<b>SB Number:</b>	<b>SB 2GR-033</b>	<b>Creation Date:</b> 01/10/2009
<b>Subject:</b>	<b>The operation panel display remains blank</b>	
<b>Model:</b>	<b>KM-3035/4035/5035/3050/4050/5050</b>

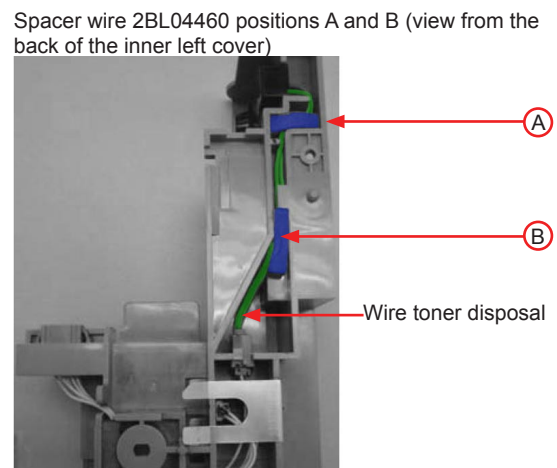
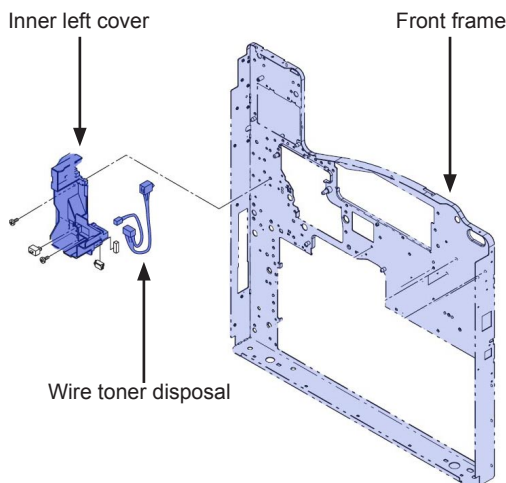
<b>Cause</b>	<p>The wire toner disposal has been damaged, after being pinched between the inner left cover and the front frame.</p> <p>Under this condition the IC on the power supply board* becomes damaged.</p> <p>*(LVU 100 302GR45011 and LVU 200 302GR45021)</p>
--------------	---

<b>Solution</b>	The spacer wire 2BL04460 has been added, to ensure that the wire toner disposal remains in the inner left cover.
-----------------	--

<b>Classification</b>	<input type="checkbox"/> Entire stock rework <input type="checkbox"/> In-field modification at next visit <input checked="" type="checkbox"/> In-field modification by case <input type="checkbox"/> No modification necessary
<b>Field measure</b>	Please make sure that the wires do not get pinched during assembly or disassembly.
